**CARMICHAEL COAL PROJECT  
GROUNDWATER FLOW MODEL  
INDEPENDENT REVIEW  
(RE: APPROVAL CONDITIONS 22 & 23)**

Prepared for	<b>Adani Mining Pty Ltd</b>	28 November 2014
--------------	-----------------------------	------------------

This report summarises the outcomes of an independent peer review by Hugh Middlemis of the Carmichael Coal Project numerical groundwater flow model developed by GHD for Adani Mining, consistent with the requirements of the Commonwealth approval Conditions 22 and 23 (EPBC 2010/5736).

Figure 1 - Carmichael Coal conceptual groundwater model (after GHD, 2014)

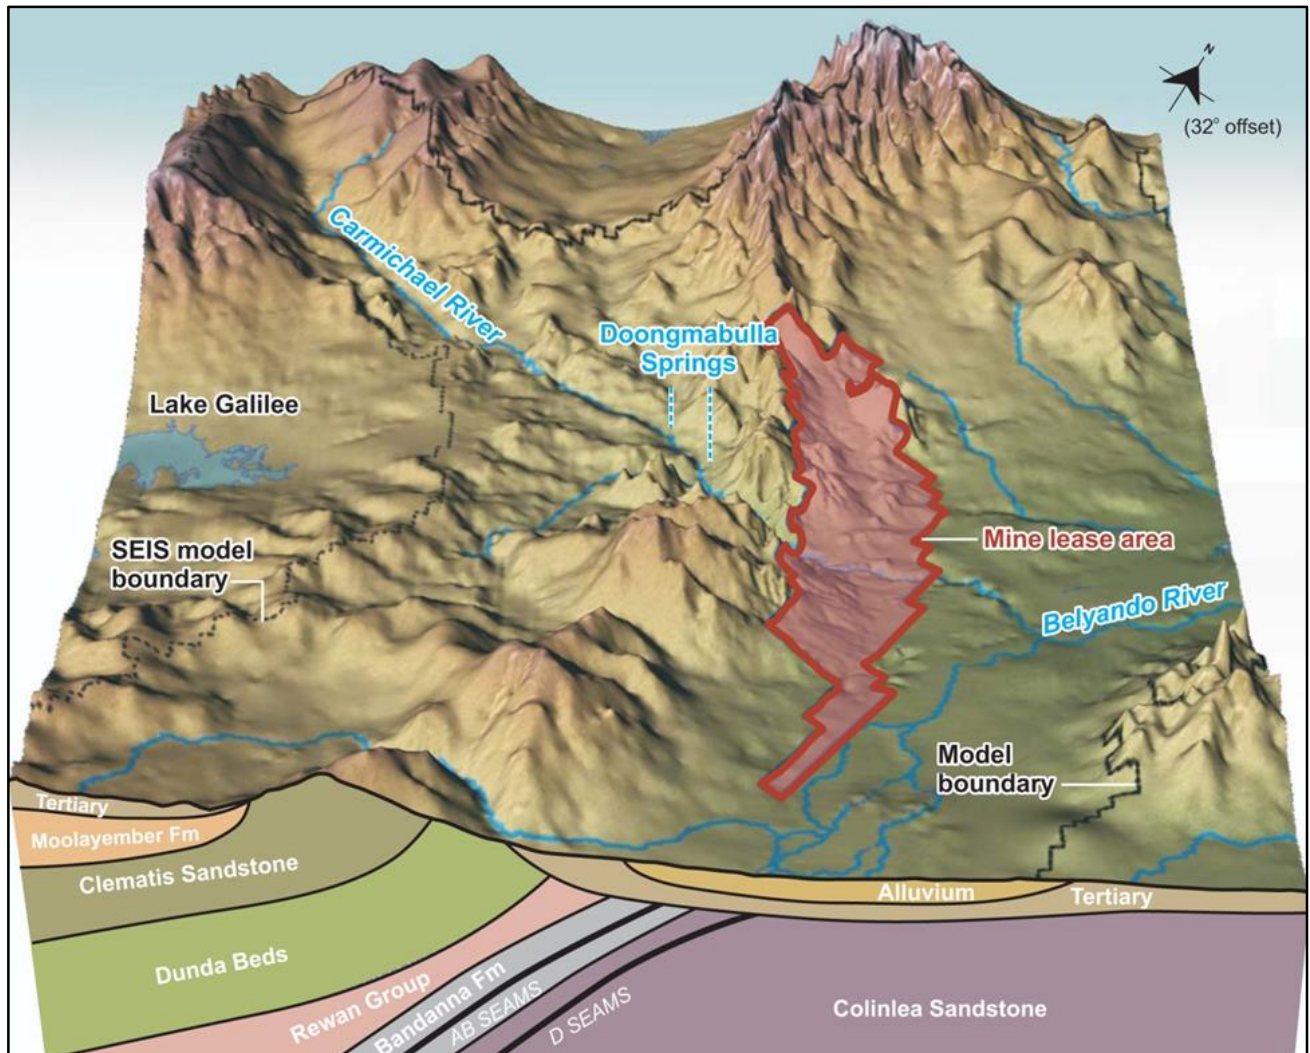
In the north-west corner, inflow is apparent from the central topographically high areas (see also Figure 1), which then largely short-circuits to outflow to the north-western boundary. It is not completely clear whether this is an accurate reflection of the flow system in this local area (data is sparse), but these conditions do not have a major effect on the gradients or levels in the main central-western part of the model. As implemented, they largely represent a local to semi-regional scale flow system that has little bearing on the main flow system under consideration and the predicted impacts (which do not extend far beyond the mine lease areas in the

Condition 23(a)(i) required the relocation of the western GHB to the western edge of the model domain (from the previous EIS/SEIS model alignment with the topographic divide east of Lake Galilee – see dashed line in Figure 1), along with review and revision of the GHB conductance parameter and cell elevations. This essentially forms an alternative conceptualisation approach that substantially helps to address uncertainty (i.e. consistent with best practice: Barnett et al, 2012; section 3.4).

**Figure 2 – Carmichael conceptual model west-east section (after GHD, 2014)**

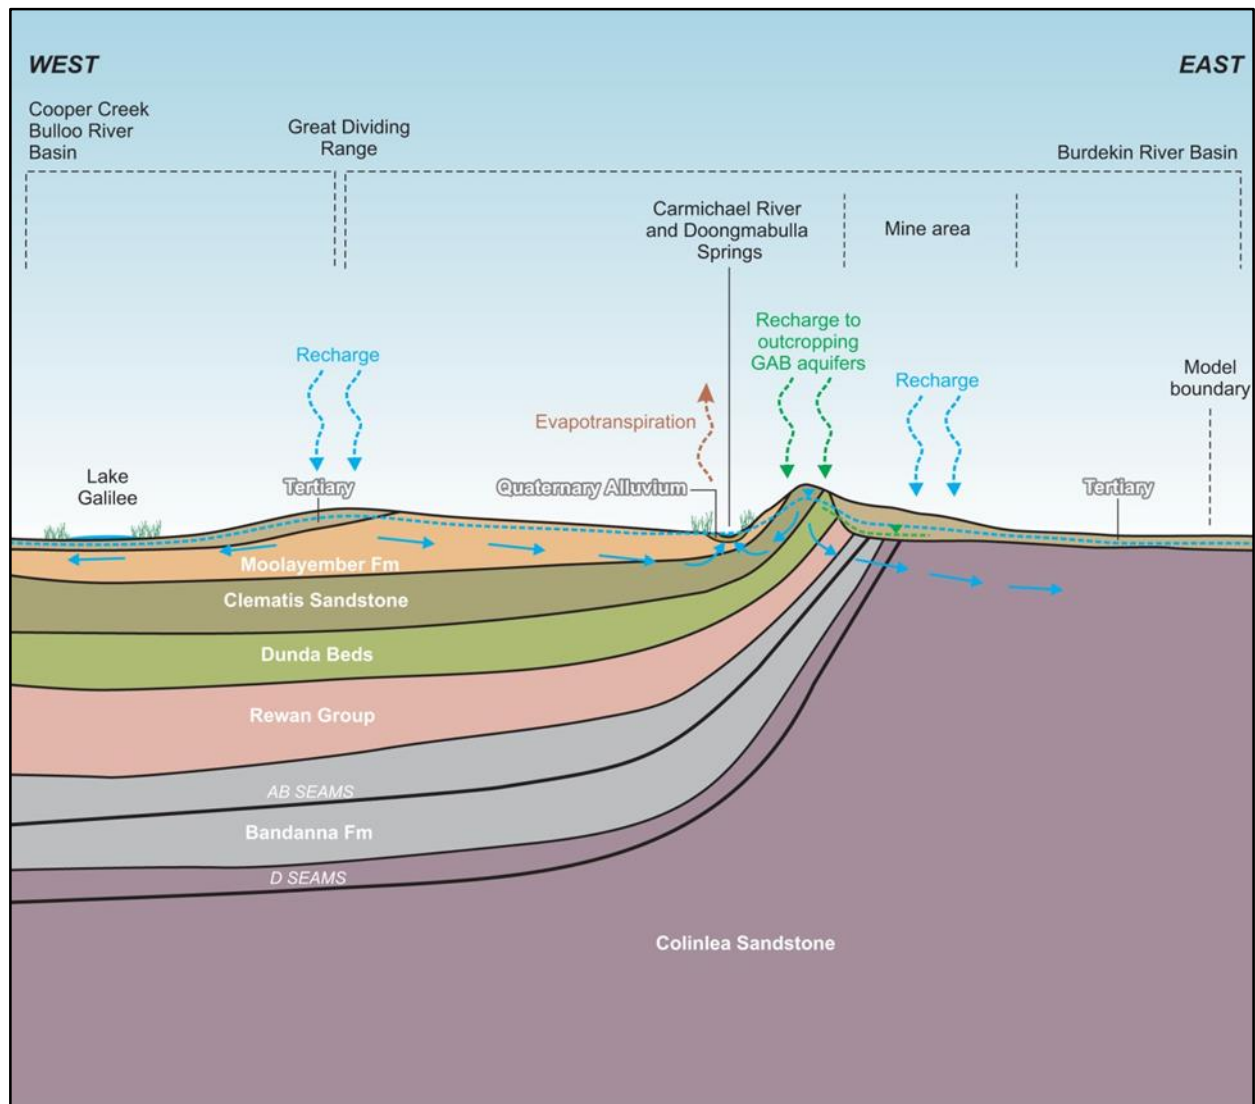
4. Is the conceptual model based on all available data, presented clearly and reviewed by an appropriate reviewer?	Yes	<p>A multi-disciplinary team from GHD has been involved in the hydrogeological data analysis and review, in consultation with DNRM hydrogeologists on key elements (mostly hydrogeological structure &amp; parameter values). Additional data was obtained to inform the 2014 western boundary revisions, and the model layer structure, properties and boundary conditions have been reviewed (with inputs from DNRM staff). Good presentation of conceptual model in 2014 report (e.g. Figure 2 herein).</p>

**Figure 3 – Geological section, mine areas and free-draining fractured zone**

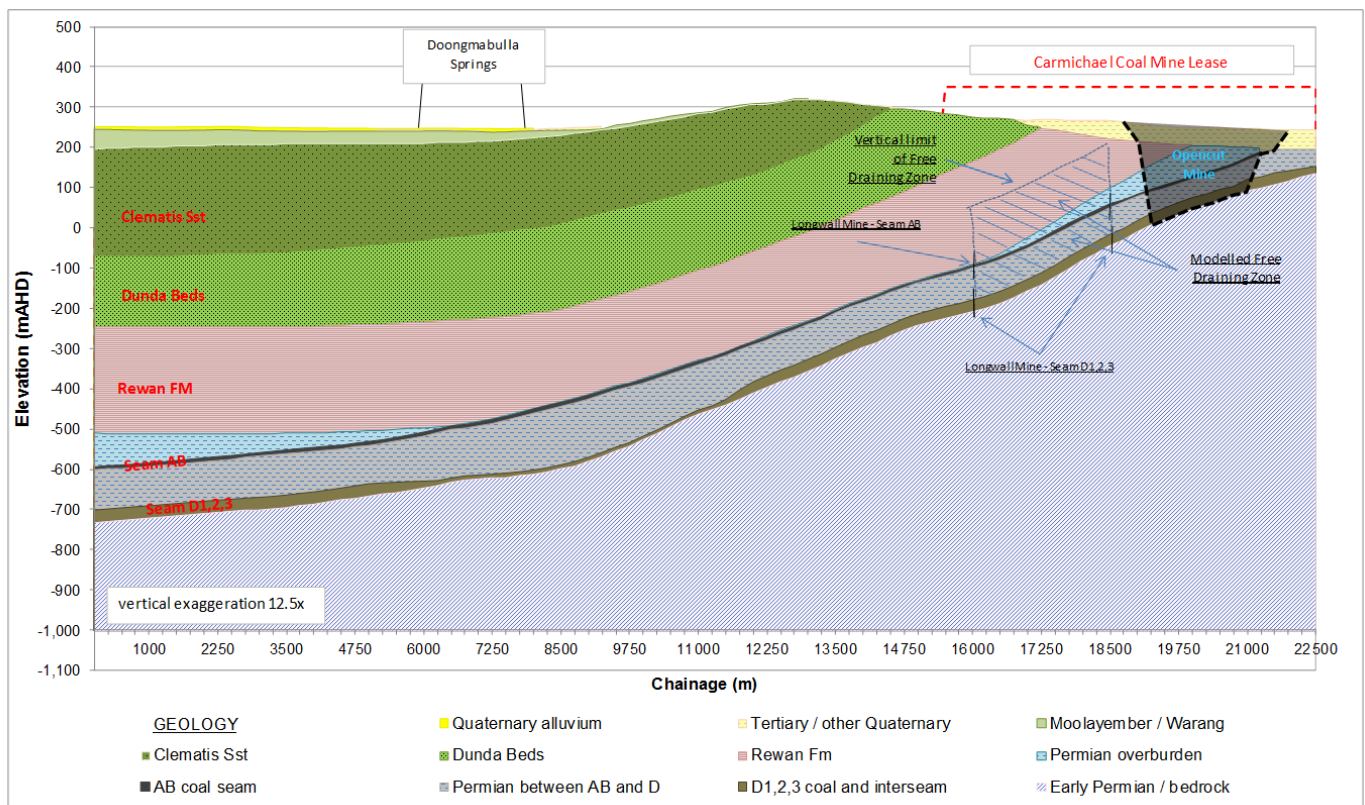
Additional parameter changes were made to the vertical hydraulic conductivity (Kv) values to represent a 150 metre thick free-draining fractured zone above the underground (SEIS, section 5.6.3; see also Figure 3 below, after GHD, 2014).

A factor of 50 was applied to the lower zone Kv and a factor of 10 was applied to the upper zone Kv. The zone extends through the overburden (layer 8) and up into the Rewan (layer 7). I note that the model reports cite research by Guo et al (2007) as the basis for fractured zone parameter assumptions. Guo et al (2007) was also used as the basis for research by Tammetta (2013) that is cited in Ditton and Merrick (2014) and has recently been shown to comprise conservatively high parameter values (i.e. it could be argued that the fractured zone assumptions that have been applied also include an allowance for non-mining fracturing of the Rewan). The runs carried out with and without this free draining fractured zone indicate that drainage through the Rewan increased by less than 4% (due to the free draining fractured zone), indicating low uncertainty on the potential effect of Rewan faulting/fracturing.
